Parks & Recreation Board Meeting

August 19, 2014

**Subject: Mill Point Park Floating Docks
Engineering Evaluation**

Figure 2

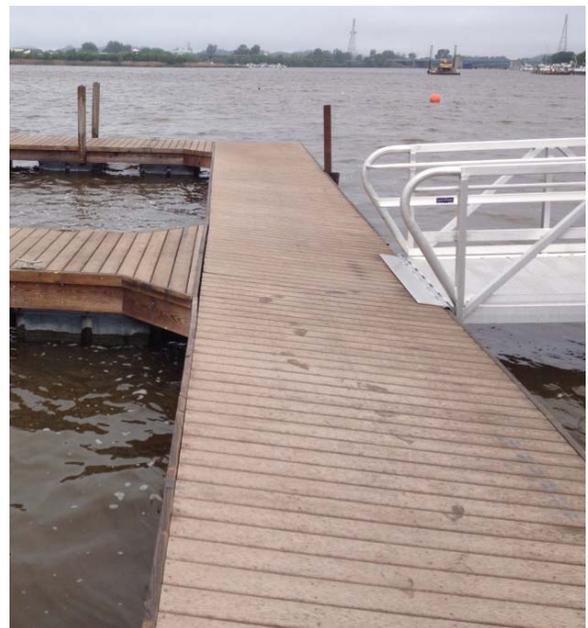
The dock floatation is not sufficient for gangway load, causing a depression in the dock at the gangway landing (Figure 2). If left in this condition, frame damage can be expected, if it has not already occurred.

We recommend adding commercially-available floatation units (Figure 7) to the dock system at the gangway landing or replacing existing units with deeper units. This work may require reconfiguration of the existing floatation units to make room for the additional units. The weight of the gangway should be obtained from Raven Marine to calculate the anticipated dead and live loads acting on the dock at the gangway landing. This information can be used to determine the proper level of floatation at the landing. The cost for floatation units varies with size, but each tub typically costs \$250 to \$500.

Figure 6

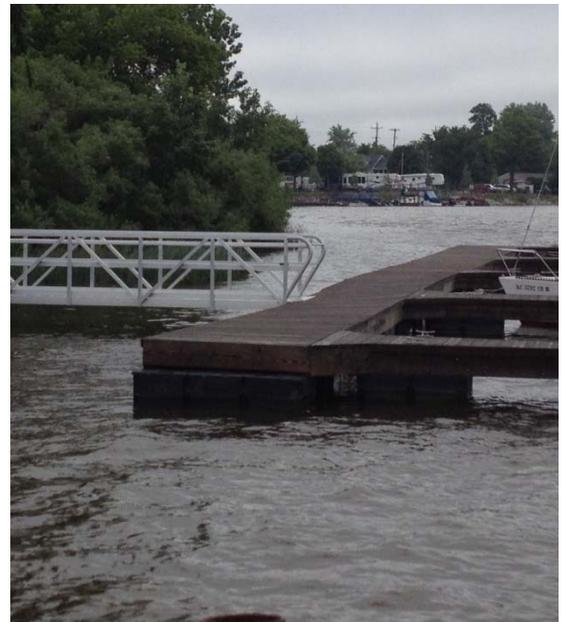
One floatation unit appeared to be loose/disconnected from the easterly dock system (Figure 6). This issue commonly results from ice forces during spring ice flows; however we understand these docks are relocated to a protected location during the winter months.

The floatation unit should be inspected for damage and re-fastened to the floating docks if it has not been damaged. If damage is observed, the floatation unit should be replaced.

Figure 8

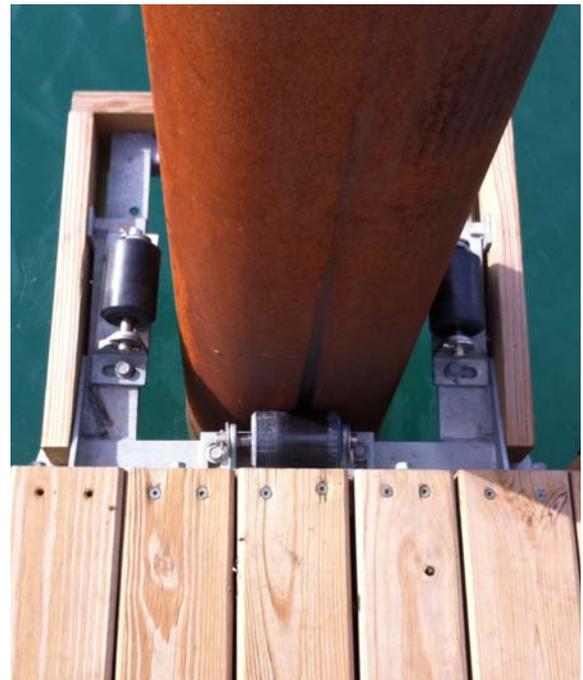
We recommend replacing the current anchorage system with a system that will hold the docks in place horizontally and allow free vertical movement. Given the perceived river flow conditions, the best anchorage system is likely a guide pile system (Figure 8). This system consists of a driven piles and guides mounted to the dock system. This system could be designed to incorporate guides which can be opened/removed during winterization to allow the docks to be relocated to a protected location, as they are now. The pile size and quantity must be properly designed to accommodate the range of anticipated conditions. At minimum, 3-4 guide piles will be required for each of the two dock systems. The cost for each pile and guide is approximately \$1,500-\$2,500, resulting in a total cost of \$10,000 to \$20,000 for replacing the anchorage system.

Figure 10

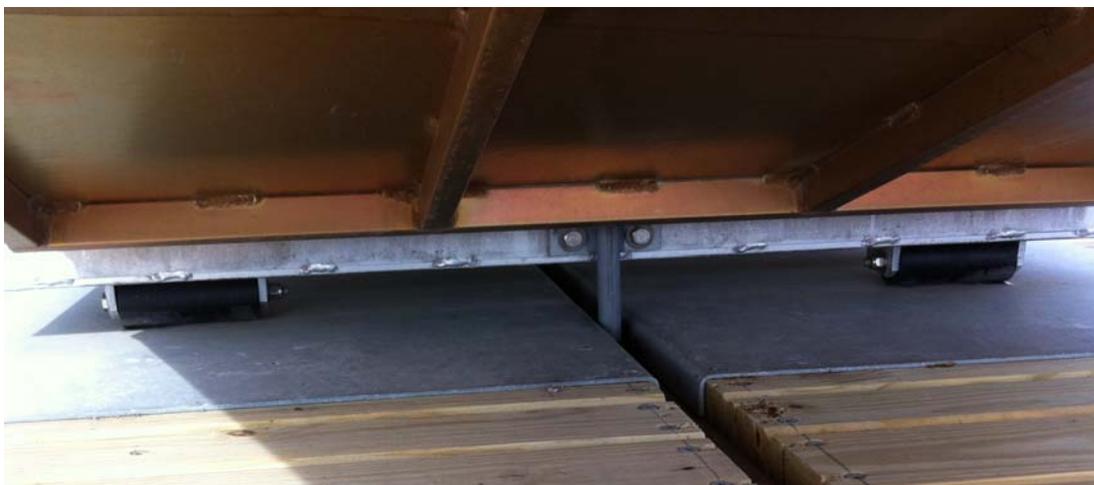
- *Roller connection at dock landing*
The current fixed connection to the floating dock could be replaced with rollers (Figure 10) that allow the gangway to rest upon the surface of the floating dock. If installed without the above fifth-wheel connection, this measure will not allow complete horizontal movement of the docks, as the wheels accommodate movement of the docks in only the direction that is longitudinal to the gangway. This measure would likely also require a longer transition plate at the dock-end of the gangway, as the gangway surface would be over six inches above the surface of the dock. Costs for each of the above modifications will vary based upon design.
